LAND AT TEVERSHAM ROAD

# FULBOURN

RESERVED MATTERS  
ADDENDUM TO  
DESIGN AND ACCESS STATEMENT

ON BEHALF OF CASTLEFIELD INTERNATIONAL LTD

Figure 7. Proposed Overview of Apartment Block A to form Streetscene Enclosure

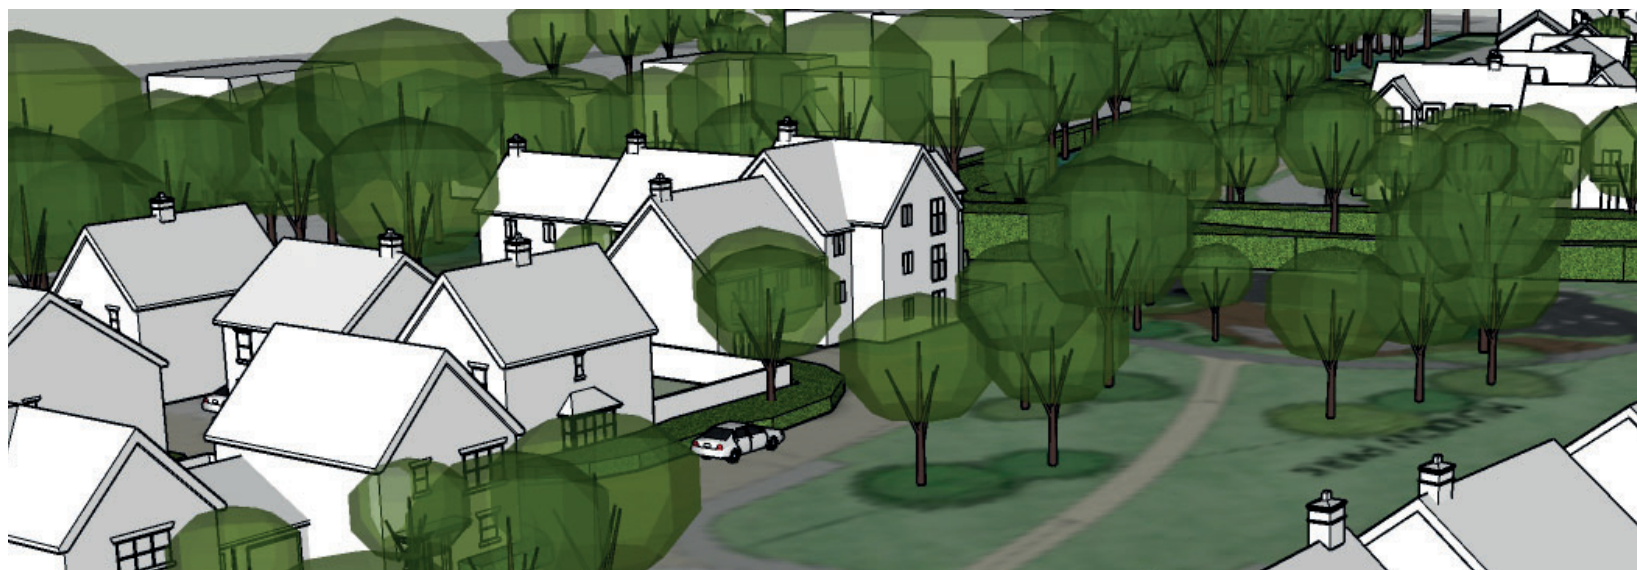
2. Awkward street break between Apartment block A and plot 55. Recommends additional residential unit to close space.
3. Apartment block B splayed frontage to spine road awkward. Recommends re-arranging.

2. Apartment Block A was redesigned to create a drive through with parking court hidden by the building mass beyond, closing the space between the apartments and house and reinforcing the streetscene. This also allows for more usable private space.
3. Apartment Block B was redesigned to remove the splayed frontage. Also, like Apartment Block A, a drive through was created, screening the parking court and reinforcing the streetscene.

Figure 31. Design Detail Through Flat Balcony

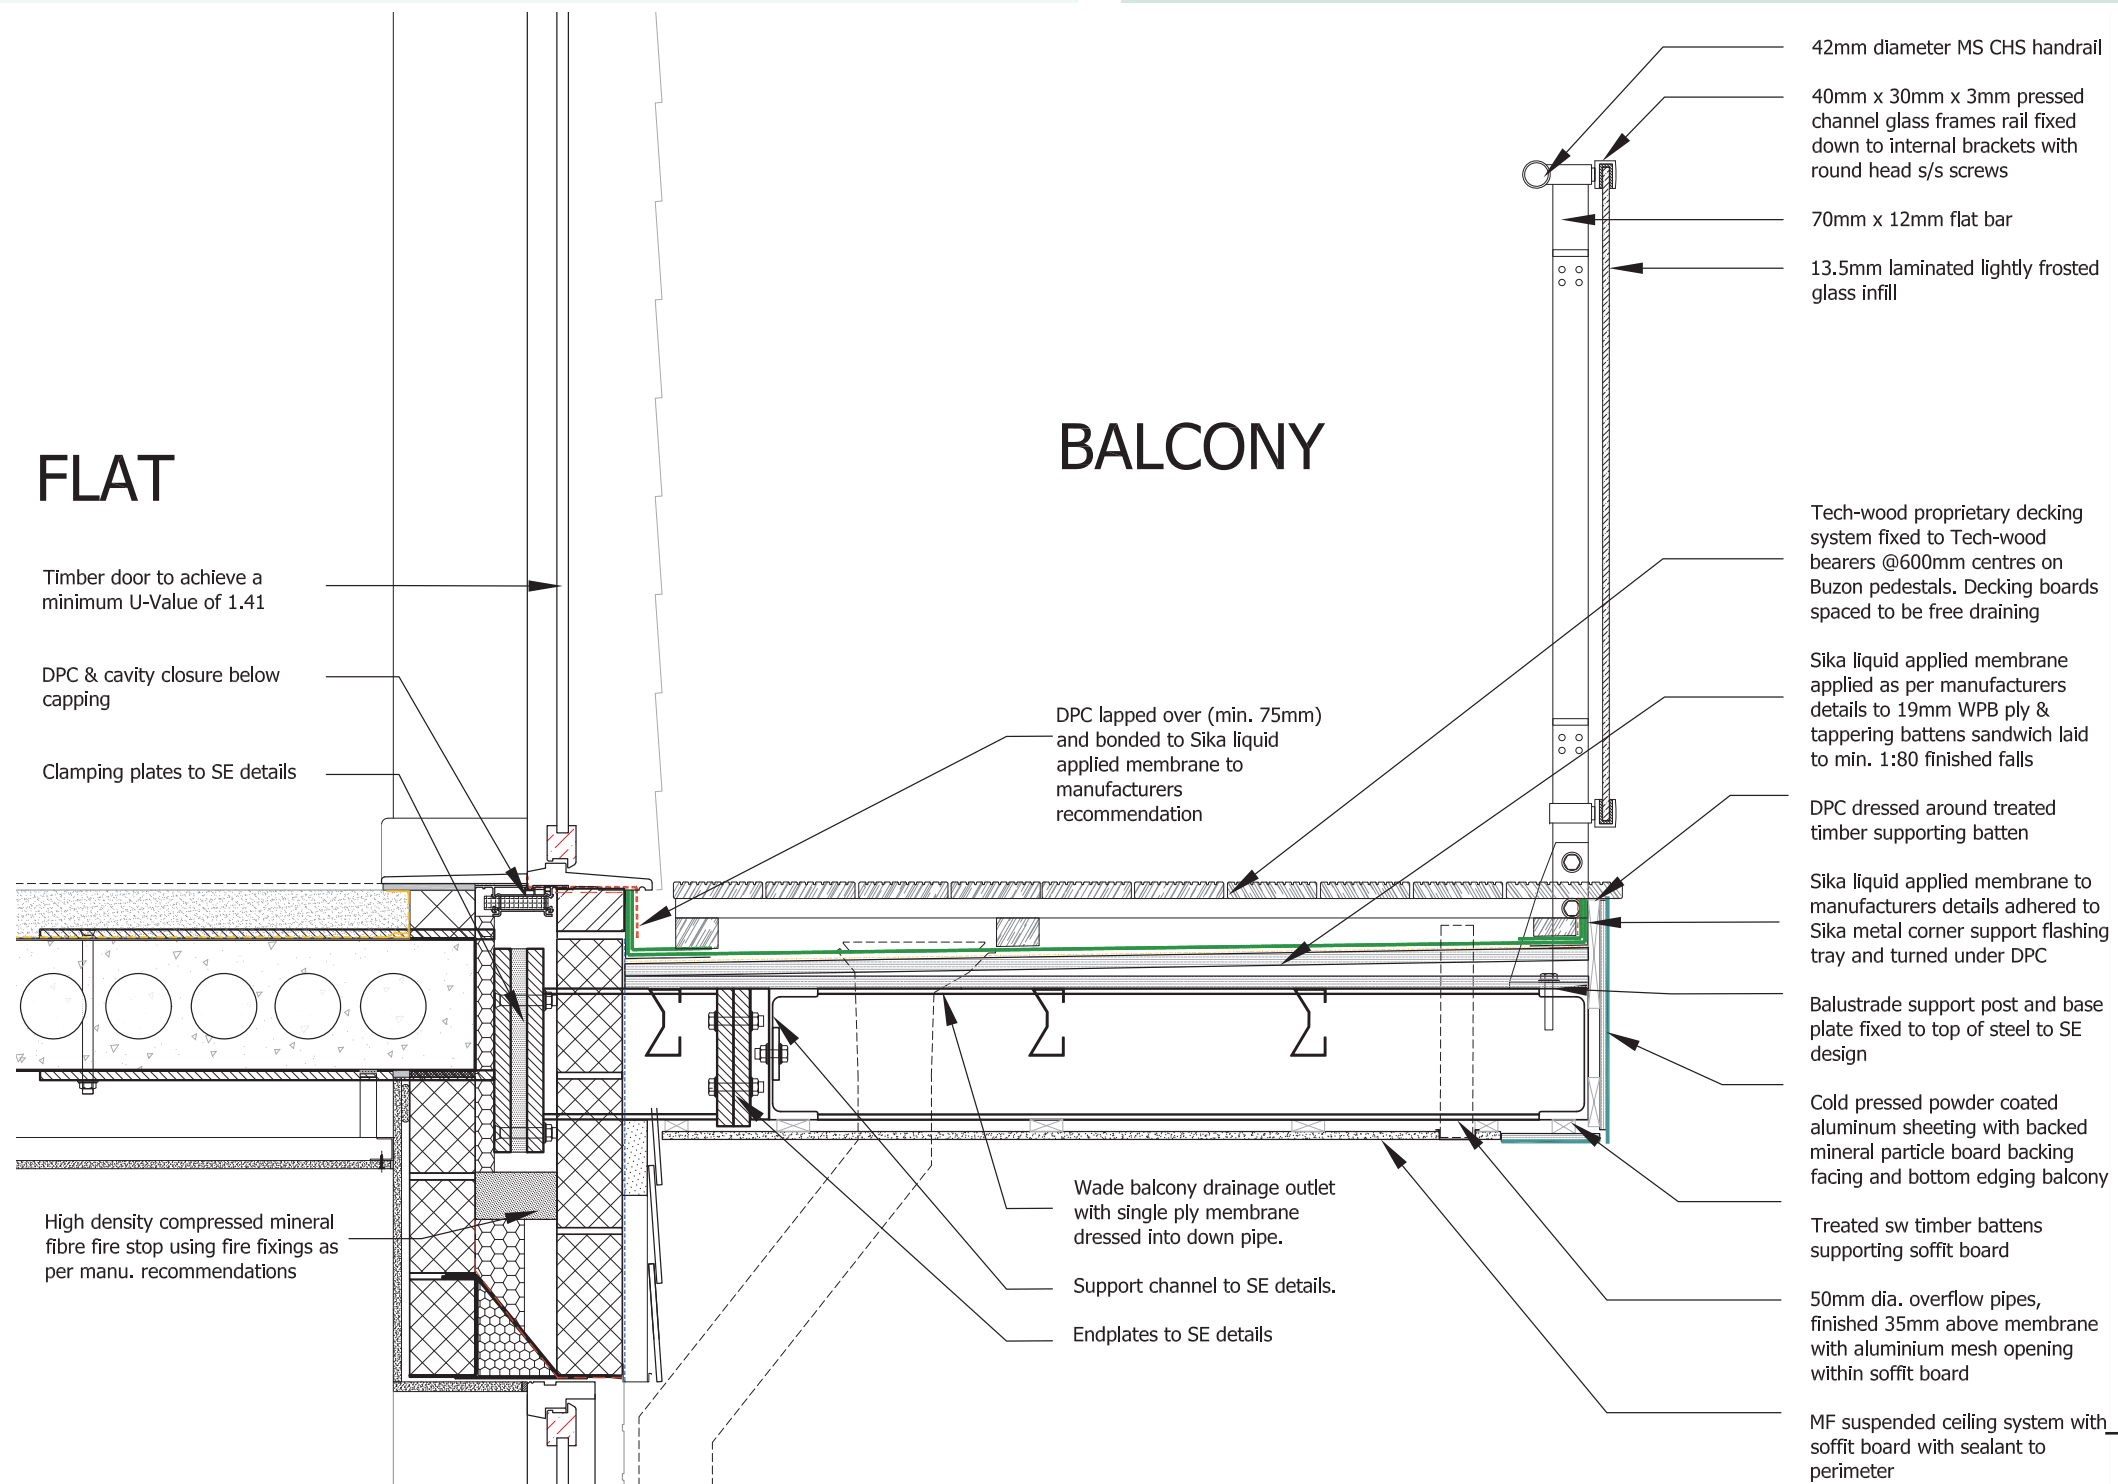
- Balconies on all flats. Detailed drawings showing colours and materials requested.

- Figure 31 shows a detailed section taken through one of the flat balconies. All balcony are to follow the same detail in materials. In terms of colour the powder coated aluminium edge trim and metal handrail shall be dark grey in the Village Lanes character area and white in the Meadow Park character area.
